**PLANNING COMMISSION MEETING STAFF REPORT**

**NAME OF PROJECT:** Southhill

**AGENDA ITEM:** Southhill Phase 3 Preliminary Approval and Conditional Use Permit

**Subject: Southhill Phase 3 PUD – Preliminary Review**

**PRELIMINARY DITCH PLAN**

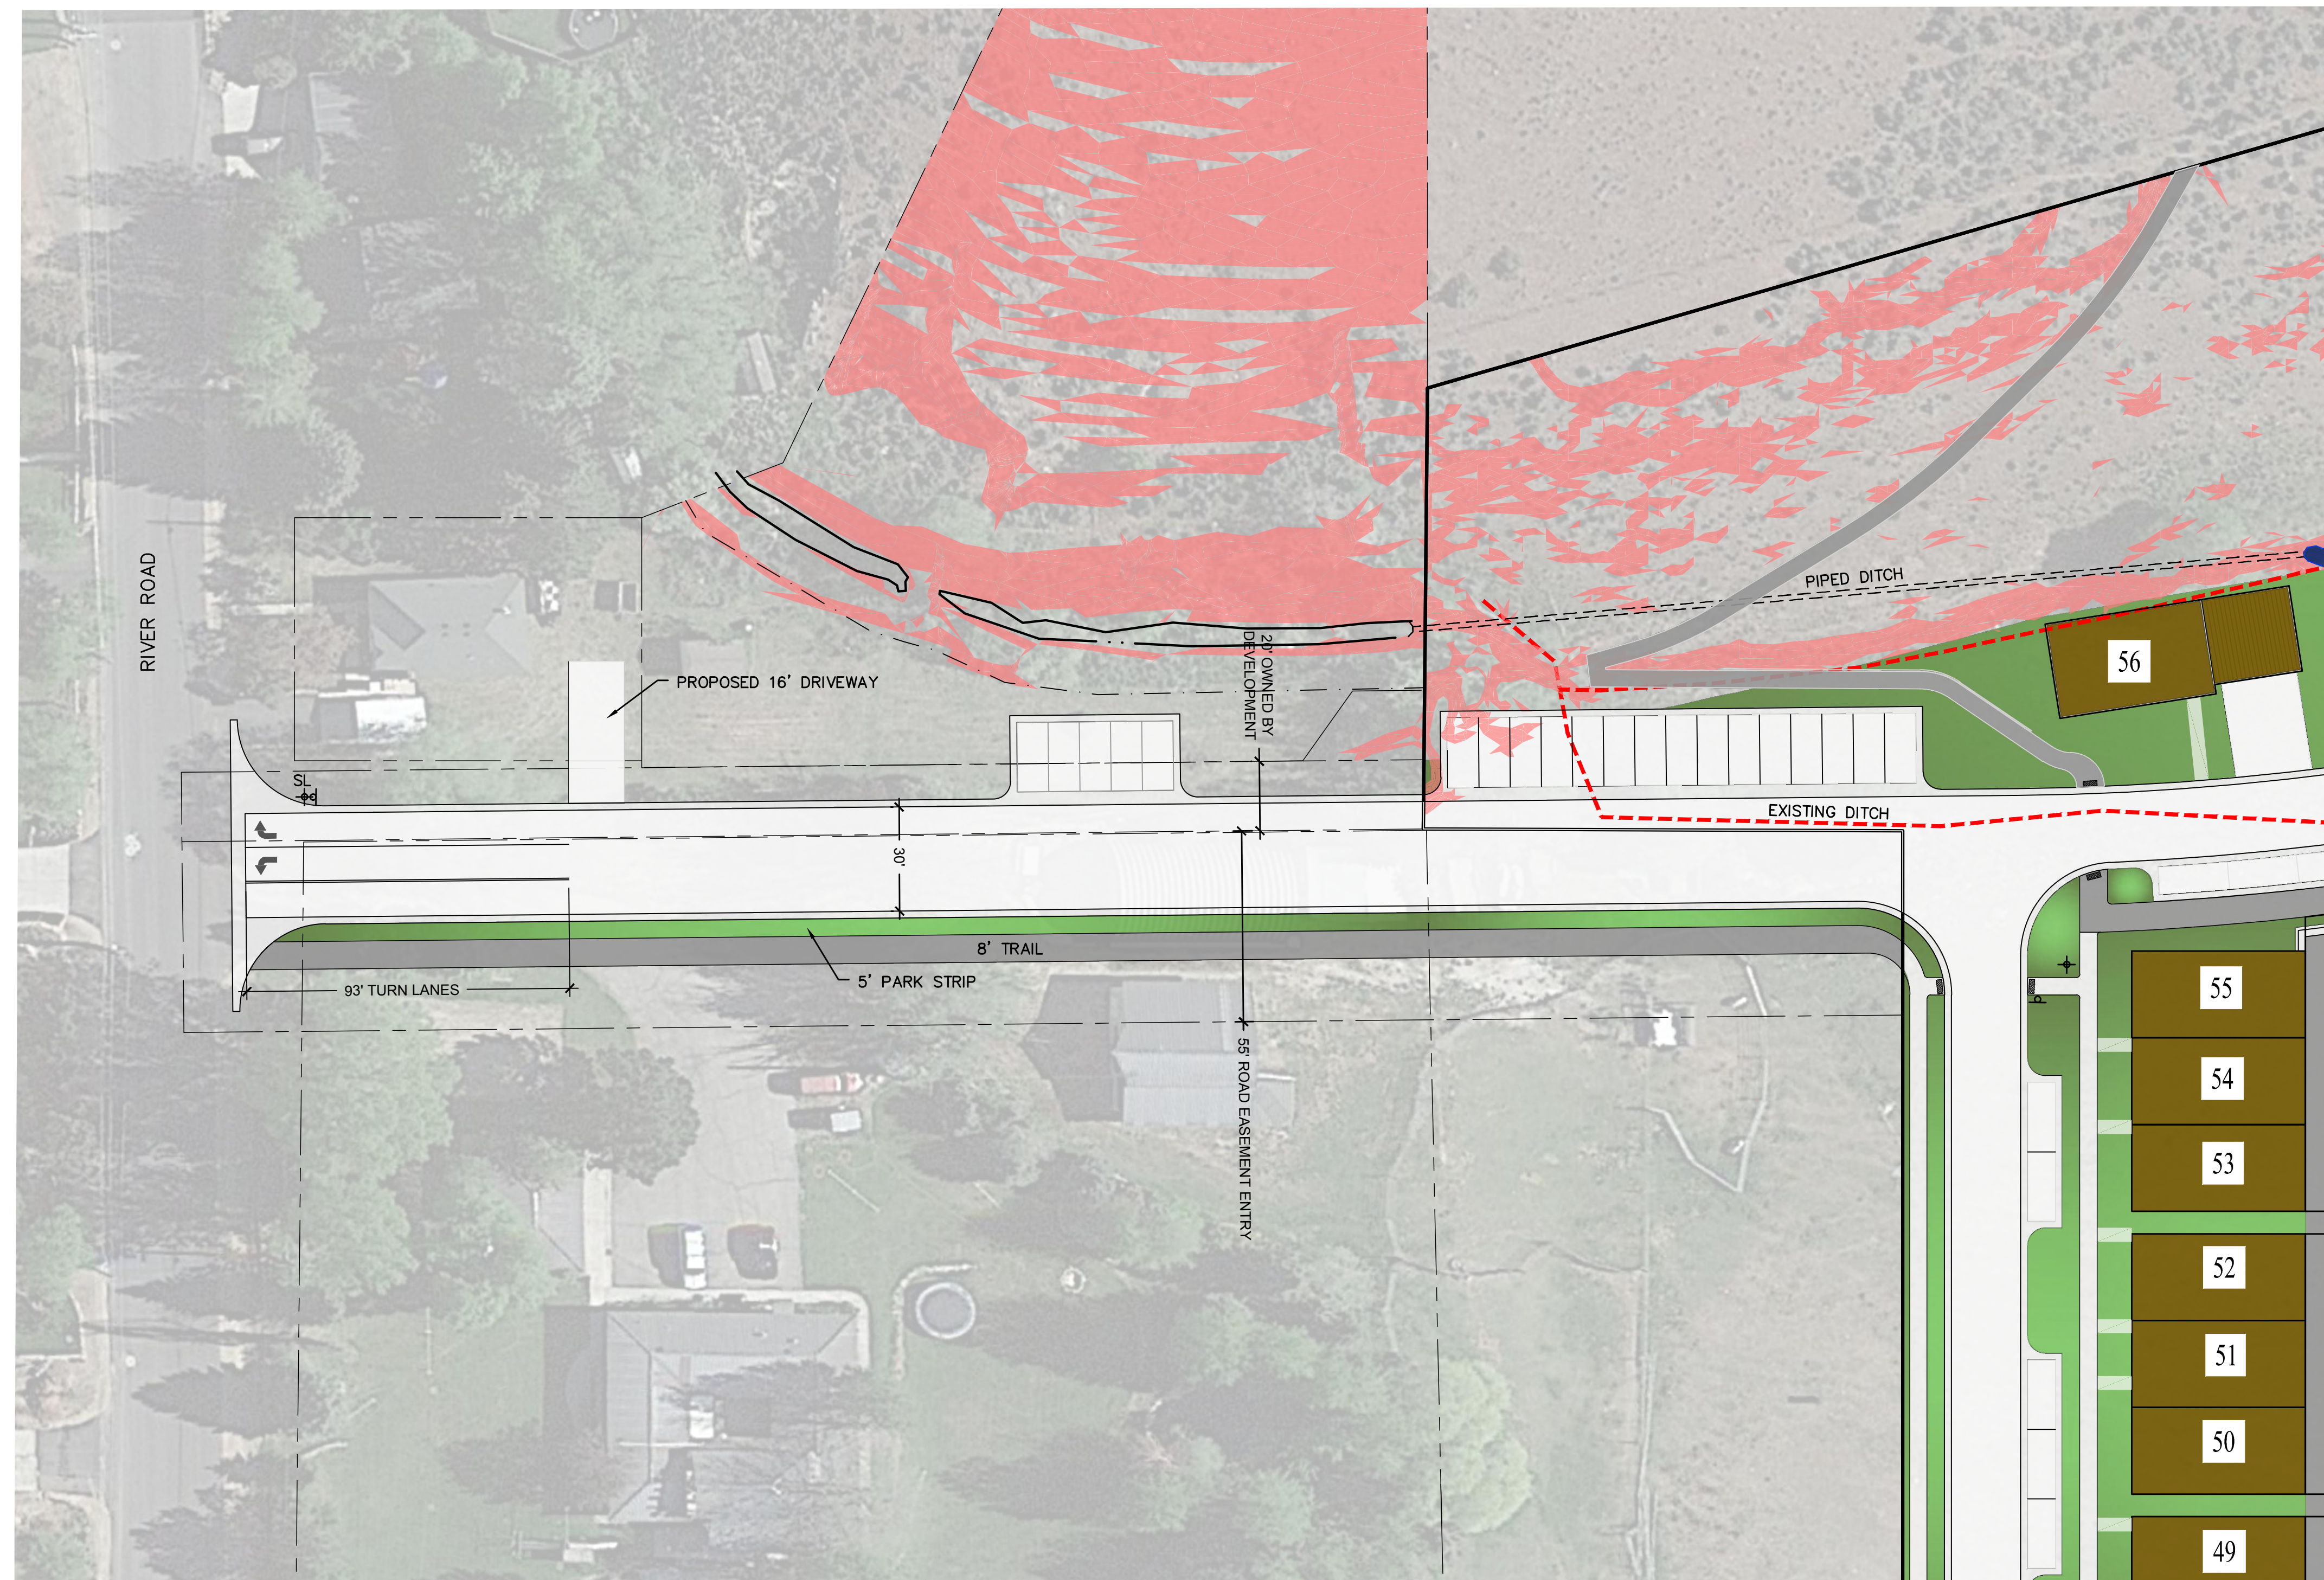
*Midway Irrigation Company Ditch* – There is an existing Midway Irrigation Company ditch that runs west to east across the property. The proposal is to reroute the ditch through parts of phases 3, 4, and 5. Midway Irrigation Company will need to review the plans and approve them before the ditch can be relocated.

- The subdivision will be serviced by the Midway Irrigation Company.
- All removal, additions, or revisions to the pressurized irrigation system must be approved by the Midway Irrigation Company.
- There is a ditch towards the north end of the property that flows west to east. The ditch is proposed to be placed in a network of culverts and open ditch as it flows under driveways to the east side of the development. All proposed work on this ditch must be approved by the Midway Irrigation Company.

LUSTER  
SOUTHILL - PHASE 3  
RIVER ROAD ACCESS PLAN

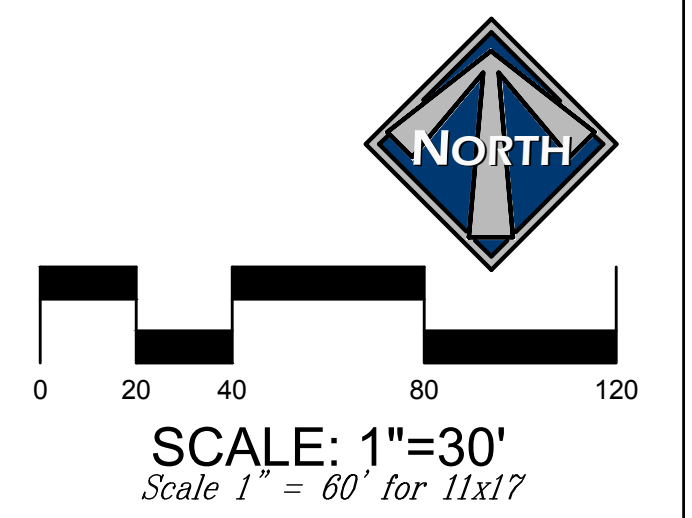
*Intersection and Driveway Location* – The proposed River Road access and the property directly north of it (OMI-0418-0, River Road Midway LLC) will have access points that are within 40’ of each other. Driveways and intersections should be separated by 40’ to avoid safety issues of them being too close together. The applicant has addressed this issue by allowing access to OMI-0418-0 to be directly from the proposed River Road access. Once driveway access is moved from OMI-0418-0 to the proposed River Road access then the existing driveway will need to be abandoned.

- The proposed roads and sidewalks within the development will be private with public access.
- An outlet to River Road will provide a dedicated left and right hand turn lane
- The timing of the traffic signal at the intersection of Main Street and River Road shall be per the master plan agreement.

1. If Wasatch County approves a trail from phase 3 to the lower road on Memorial Hill, the developer is responsible for the design and construction of the trail in phase 3 and on Wasatch County property.
2. Dumpster locations and enclosures must be shown on the plans.
3. Driveway access must be granted on the private road from River Road to Southill for parcel OMI-0418-0 because of the 40' code requirement between driveways and road intersections. Also, a signed document between the developer and the owner of parcel OMI-0418-0 must be provided that grants access and acknowledges that the existing driveway will be abandoned.
4. The applicant must receive approval from Midway Irrigation Company to reroute the ditch that crosses phase 3.
5. Plans must be submitted with the required landscaped island on the River Road access.
